Proposal for Parallel SCSI: Increase Transfer Rate and Improve Error Detection

To: T10 Technical committee
From: Jim McGrath
Quantum Corporation
500 McCarthy Boulevard
Milpitas, CA USA 95035
Phone: 408-894-4019
Fax: 408-952-3620
Email: jim.mcgrath@quantum.com
Date: ~~September 11~~ August 17, 1998

Figure 2 -- CRC_AVAILABLE timing

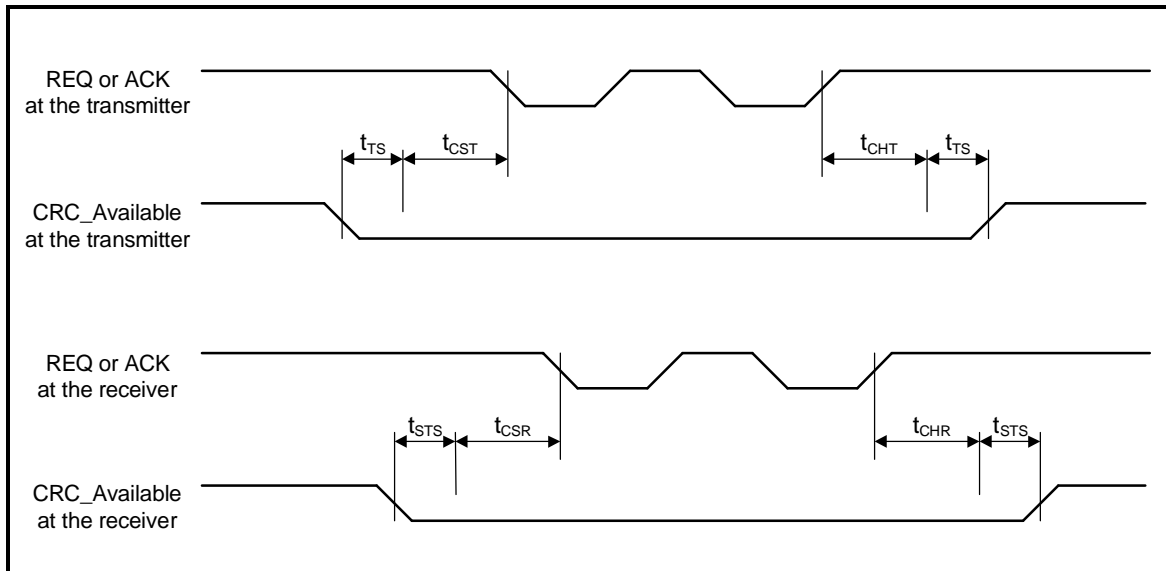
[Note: in the second t_{STS} , there should be additional setup time to allow CRC_AVAILABLE to transition. Following the precedence for setup to CRC_AVAILABLE, it is suggested that an extra 10 ns setup be added here. – CC_AVAILABLE setup time is 10 ns additional on either assert or deassert with request to REQ.]
